Service Bulletin

Drifting resistance on "H" circuit.

Picture 1

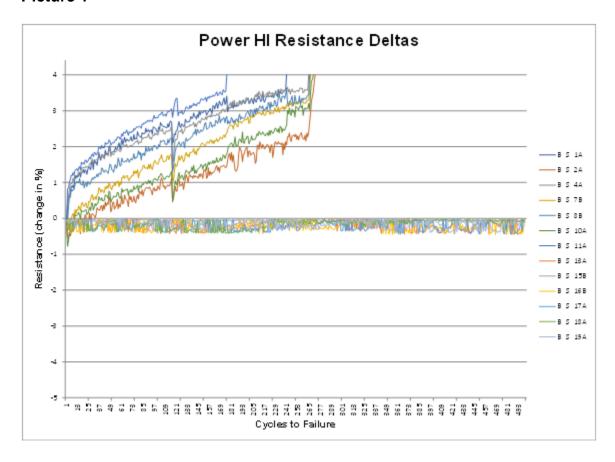
PWBi has become aware of an issue with certain test results showing a slowly increasing resistance on the H circuit (see Picture 1 below). This can lead to the system rejecting the H circuit and in some cases the S circuit. This issue is caused by a copper diffusion into a tin-lead surface finish at high temperatures over an extended period.

At higher temperatures and over an extended period the copper of the H circuit will diffuse into the tin lead solder finish causing the cross-sectional area of the H circuit trace to be reduced. This will only affect coupons being tested with these parameters:

- an external H circuit.
- tin lead surface finish.
- tested ≥190 °C.
- cycles > 100.

As the H circuit is constructed entirely of foil and plated copper there is no structure that can fail or change. Therefore this result is an error.

PWBi has made a software feature to compensate for the failure mode as depicted in Picture 1. The software feature will be listed in the Job settings tab as "Control Circuit Feedback" (see Picture 2 below). For coupons which meet the above criteria this setting should be set to "H". Software updates will be made available to all systems owners requiring this feature. If you have any questions or concerns, please contact Jason Furlong at 1-613-254-7004 or Jasonf@pwbcorp.com
